Access Compliance Report

Public Rights-of-Way

(Curb Ramps)

Intersection ID: 11424	Main Street: GLENVILLE_AV	Cross Street: STONEHAVEN_DR	Location: NE
ADA ID: 868ADB3F2038	Ramp Type: Perp	Initial Pass/Fail: Pass	Overall Compliance: No
		Severity Score: 7.5

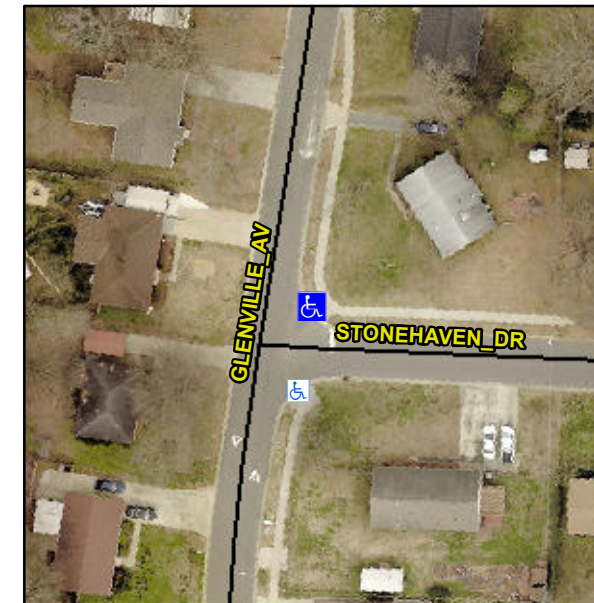
Not Found, R304.2.1, R304.2.2-Perp, R304.3.2-Para, R302.7.2

Remove & Replace Entire Ramp.
